# CERTIFICATE OF CORRECTION

MILLRIDGE SUBDIVISION NO. 4

P.V. 109, P. 21

PART OF ORIGINAL RIDGEVILLE TOWNSHIP LOT NUMBER 31  
CITY OF NORTH RIDGEVILLE, COUNTY OF LORAIN, STATE OF OHIO

# CERTIFICATE OF CORRECTION

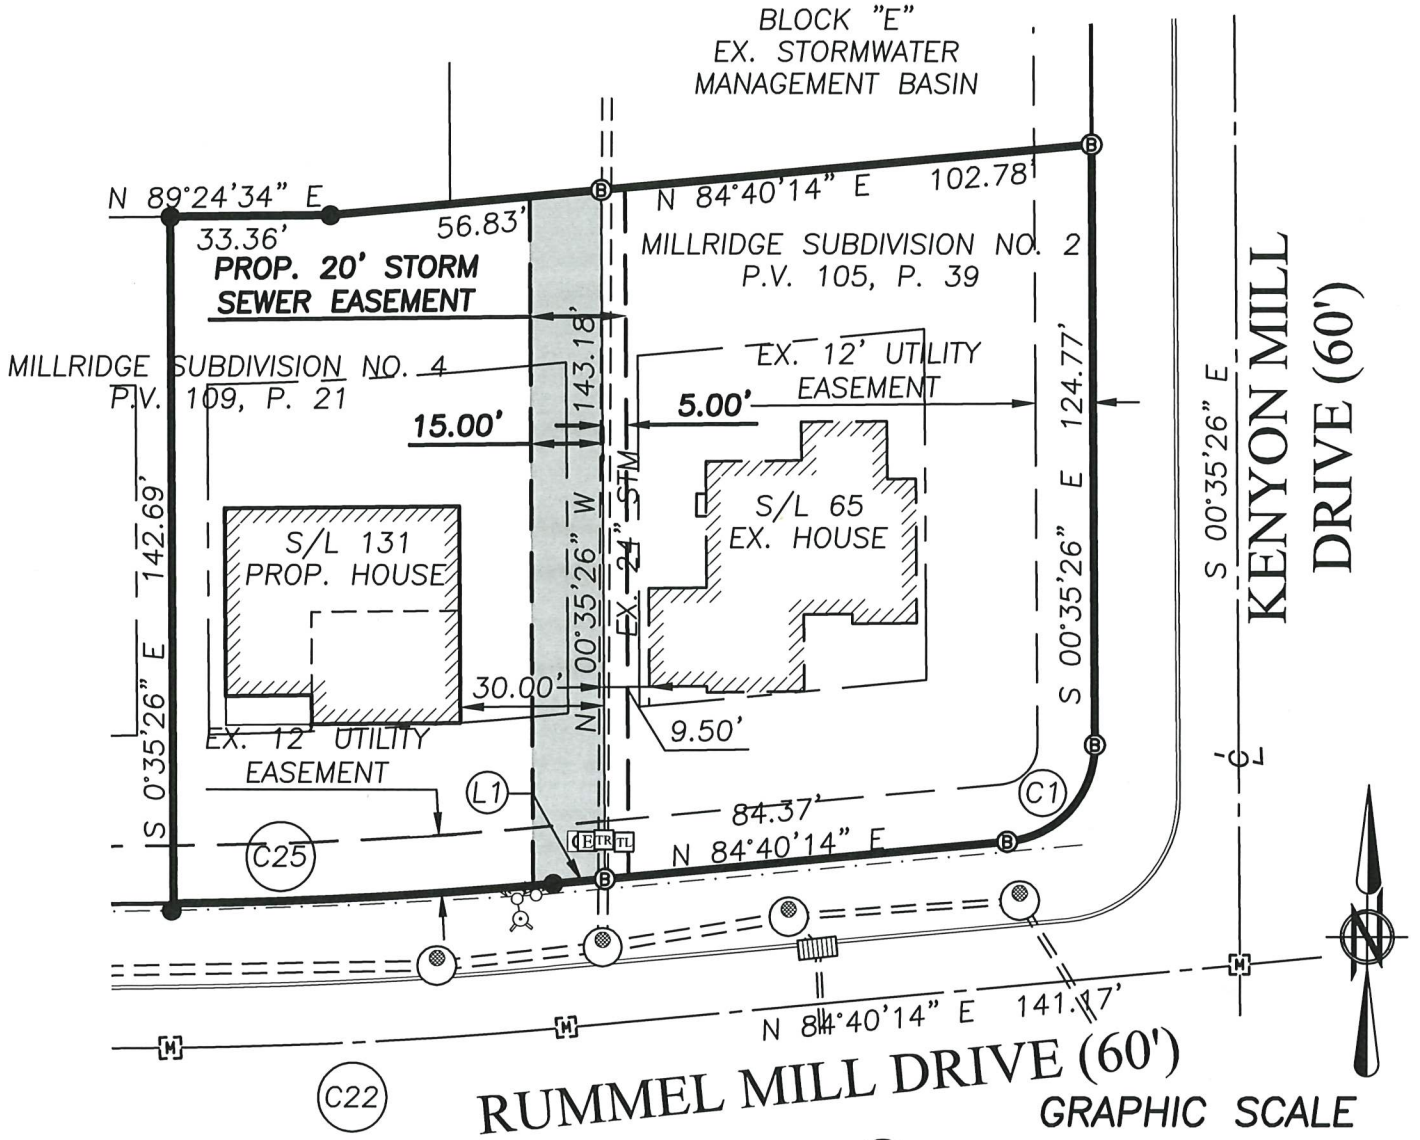
1. Sublot 131 a 15-foot storm sewer easement should be added along the east property line.
